UNITED STATES
NUCLEAR REGULATORY COMMISSION
WASHINGTON, D. C. 20555

SUBJECT: NRC REQUIREMENTS FOR AUXILIARY FEEDWATER SYSTEMS AT POINT BEACH
NUCLEAR PLANT, UNITS 1 AND 2

ENCLOSURE 1

AUXILIARY FEEDWATER SYSTEM (AFWS)

Auxiliary Feedwater System
Pt. Beach 1 & 2
Figure 1

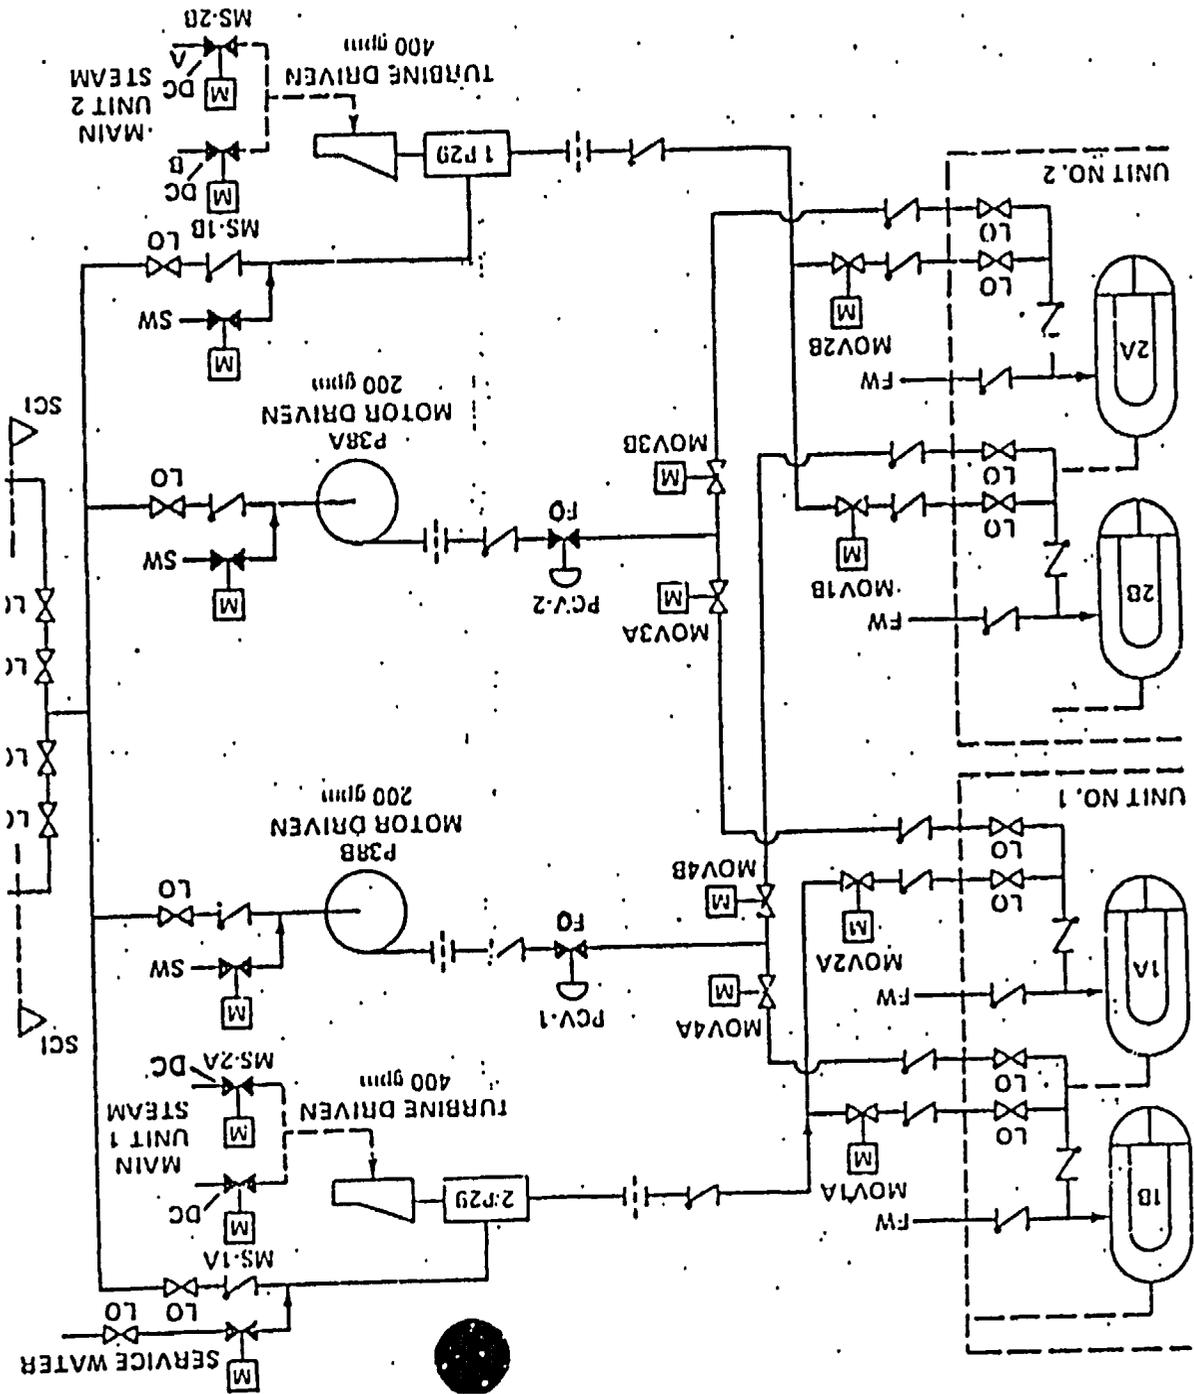
A simplified flow diagram of Point Beach 1 and 2 AFWS is shown in Figure 1. The automatically initiated auxiliary feedwater (AFW) system for each Point Beach Unit is partially shared between units 1 and 2 to supply AFW to both steam generators of each unit. Each AFWS system uses a turbine drive pump and a motor driven pump. The turbine driven pump of one unit feeds both steam generators of that unit only. The motor driven pump of each unit feeds one steam generator in each unit and therefore is shared between units. The turbine driven pumps supply AFW to the main feedwater piping inside containment through a motor operated valve for each steam generator of their respective units. The motor operated valves (MOV 1A and 2A for Unit 1, MOV 1B and 2B for Unit 2 on Figure 1) are normally opened in a throttled position to supply design flow to each steam generator. On loss of power these valves fail as-is.

Each of the two motor driven pumps supplies AFW to one steam generator of each unit through individual motor operated isolation valves which are normally open and fail as-is on loss of power. (MOV 3A and 3B from one pump and MOV 4A and 4B from the other pump). A pressure control valve (PCV-1 for Unit 1, PCV-2 for Unit 2) at the discharge

Since all valves in the flow path to the steam generators are normally open and fail as-is (with exception of PCV-1 and 2 which fail open) a loss of A-C or D-C power does not require valve manipulation. The motor operated steam valves at the inlet to the turbines (MS-1A and 2A for Unit 1, MS-1B and 2B for Unit 2) are D-C motor operated valves and will automatically open in the event of a loss of all A-C power.

One dominant failure contributor is a combination of human failure to open, following a maintenance action, a suction line valve from the condensate storage tank (assuming only one of the two tanks were lined up), combined with human failure to recognize the situation and initiate service water supply to the auxiliary feedwater pumps.

The dominant failure contributor is loss of both motor-driven pumps and subsequent failure of the turbine driven pump due to loss of service water (AC) cooling to steam turbine pump bearing oil.

The principal noted dependency is the design for AC cooling of the turbine driven pumps.

1. Recommendation GS-1 - The licensee should propose modifications to the Technical Specifications to limit the time that one AFW system pump and its associated flow train and essential instrumentation can be inoperable. The outage time limit and subsequent action time should be as required in current Standard Technical Specifications, i.e., 72 hours and 12 hours, respectively.

2. Recommendation GS-2 - The licensee should lock open single valves or multiple valves in series in the AFW system pump suction piping and lock open other single valves or multiple valves in series that could interrupt all AFW flow. Monthly inspections should be performed to verify that these valves are locked and in the open position. These inspections should be proposed for incorporation into the surveillance requirements of the plant Technical Specifications. Recommendation GL-2 for the longer-term resolution of this concern.

Recommendation GS-5 - The as-built plant should be capable of providing the required AFW flow for at least two hours from one AFW pump train independent of any alternating current power source. If manual AFW system initiation or flow control is required following a complete loss of alternating current power, emergency procedures should be established for manually initiating and controlling the system under these conditions. Since the water for cooling of the lube oil for the turbine-driven pump bearings may be dependent on alternating current power, design or procedural changes shall be made to eliminate this dependency as soon as practicable. Until this is done the emergency procedures should provide for an individual to be stationed at the turbine-driven pump in the event of the loss of all alternating current power to monitor pump bearing and/or lube oil temperatures. If necessary, this operator would operate the

1. Recommendation GL-3 - At least one AFW system pump and its associated flow path and essential instrumentation should automatically initiate AFW system flow and be capable of being operated independently of any alternating current power source for at least two hours. Conversion of direct current power to alternating current is acceptable.

3. Recommendation-GL-5 - The licensee should upgrade the AFW system automatic initiation signals and circuits to meet safety-grade requirements.
